ADMINISTRATIVE AMENDMENT
FILE # 13-1022 PROJECT # 1002134
New lot line to allow creation of 2 new tracts
Catalina de la Cruz
APPROVED BY *[Signature]*
DATE *11/13/13*

SITE PLAN FOR SUBDIVISION
TRACTS 1 THRU 19
VISTA DEL NORTE

SITE PLAN FOR SUBDIVISION

Las Lomas Industrial Park

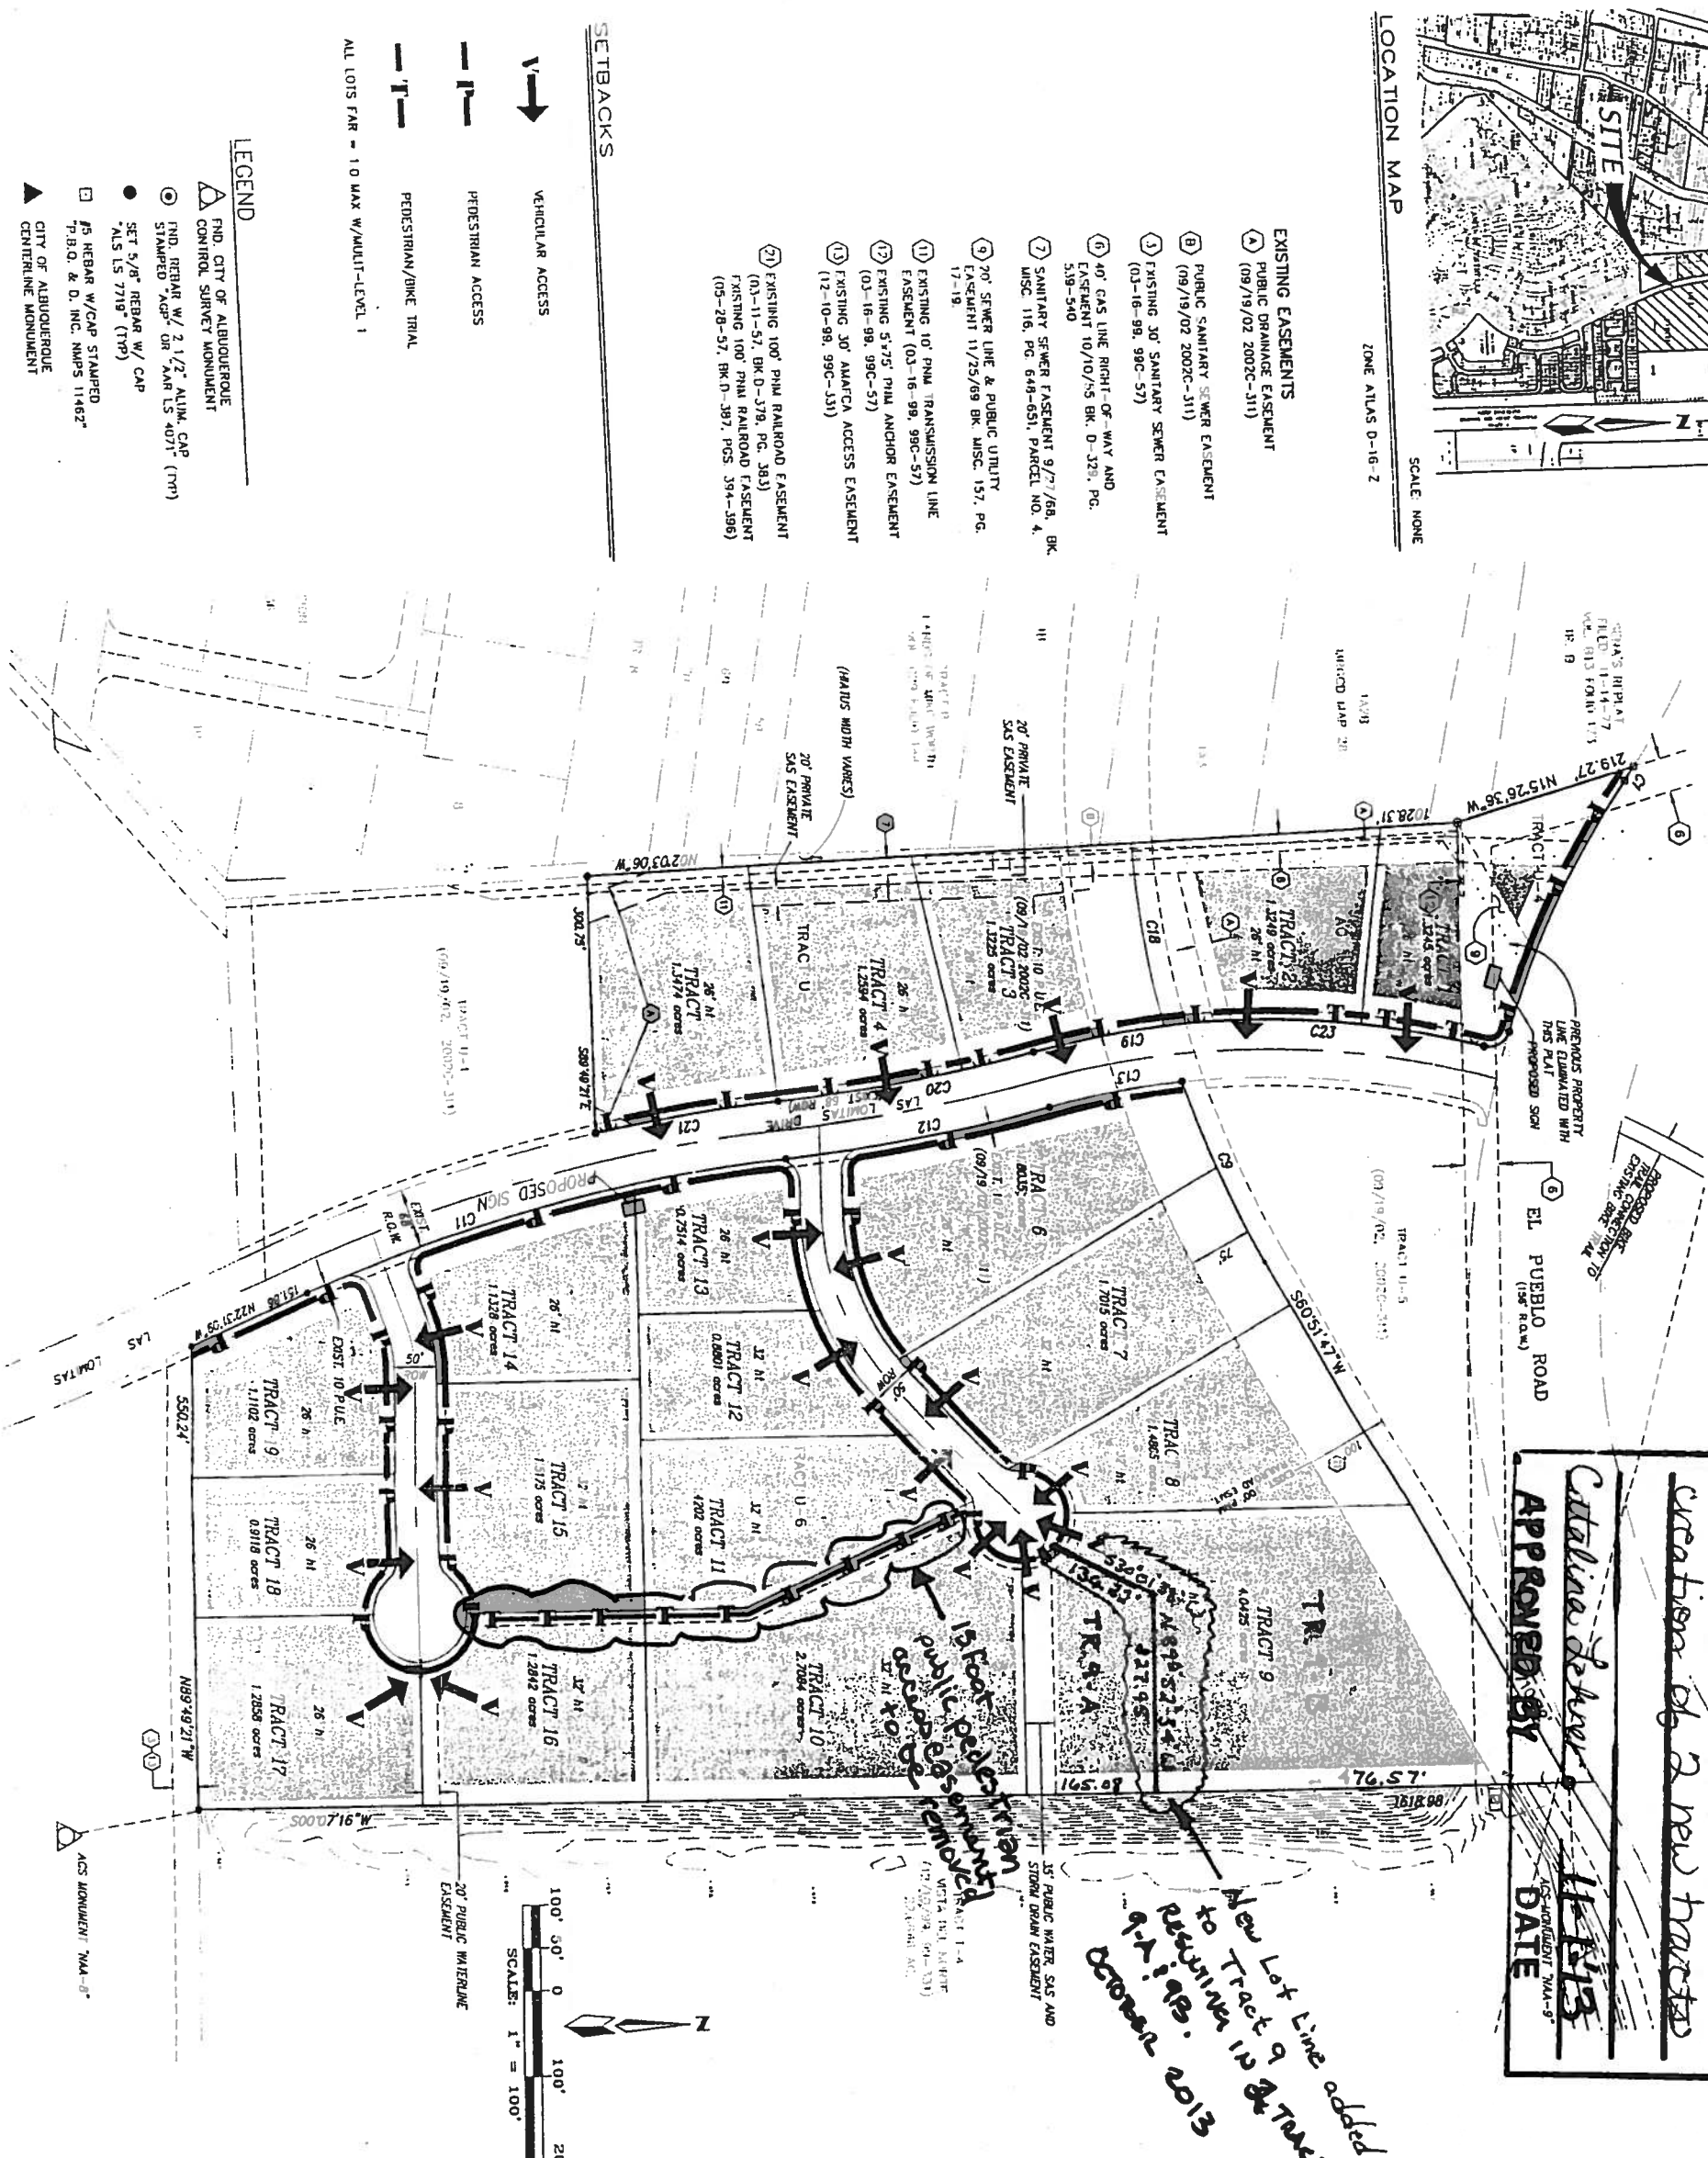
New Lot Line added to Tract 9 resulting in 2 tracts 9-A & 9-B. October 2013
